**From:** Hilary Saunders  
**Sent:** 13 June 2012 12:46  
**To:** Planning  
**Cc:** Edward Freedman; Clair Shields  
**Subject:** FW: Bay Ness Farm  
**Attachments:** S.4390.003 Rev B. Proposed elevations and first floor plan.pdf

Project: Bayness Farm  
 Robin Hood's Bay  
 Whitby YO22 4JP

Drawing: Proposed Elevations and first floor plan

Job. no. Dwg. no. Rev.  
 s.4390 003 B

NORTH WEST

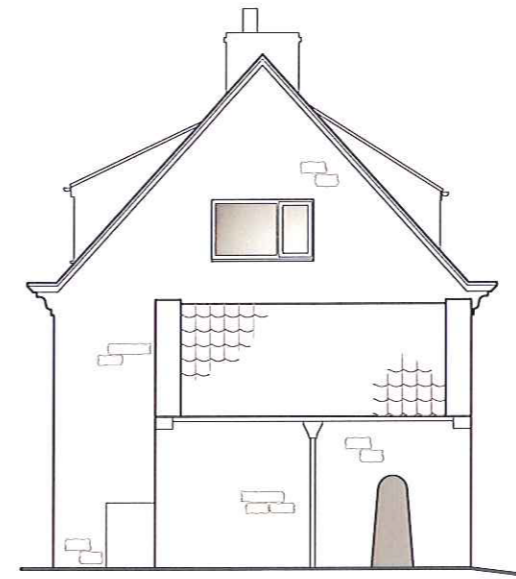
The dormer window facing the yard (North West) is as per the previous drawings showing the reduced scale/size initially asked for by the NYMNP officer. A width of 1.5m was stated in discussions and this has been met. From review of old drawings of the yard and the surrounding buildings, the previous dormer is shown as 5ft wide. This equates to 1.52m. The previous window was 4ft high equating to 1.219m. The proposed window is 900mm high which is a significant reduction.

Dormer to NW Elevation amended as follows:-

- window reduced to 1250mm wide
- window reduced in height to 900mm
- side cheeks to be covered in lead
- window to be flush fitting

SOUTH EAST

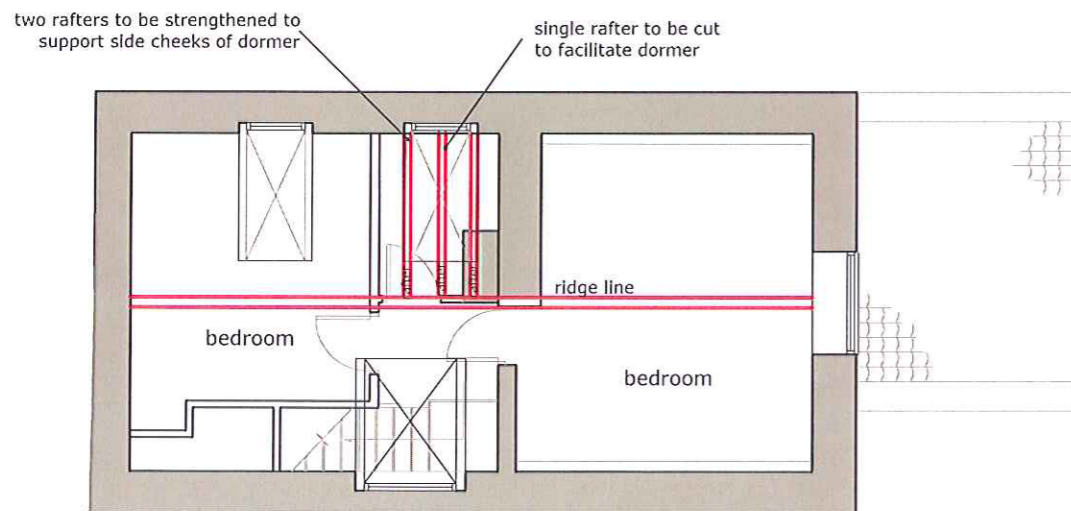
- The ridge line
- The position of the rafters in the w.c.
- The revised position of the dormer serving the w.c. to reduce the impact on the roof structure.
- Revised size of dormer facing the yard (North West Elevation)
- Reduced height of dormer window roofs to South East. They have been amended downward from the ridge line.

The requirement for the dormer to the w.c. has been questioned. This has been proposed are they are currently no bathing facilities at first floor level and the client would intends to install a shower cubicle. The extra room provided by the dormer is therefore crucial.

- w.c. dormer moved to reduce impact on existing roof timbers. Only single rafter to be altered.
- both dormers on south east roof reduced in size down from the ridge line.
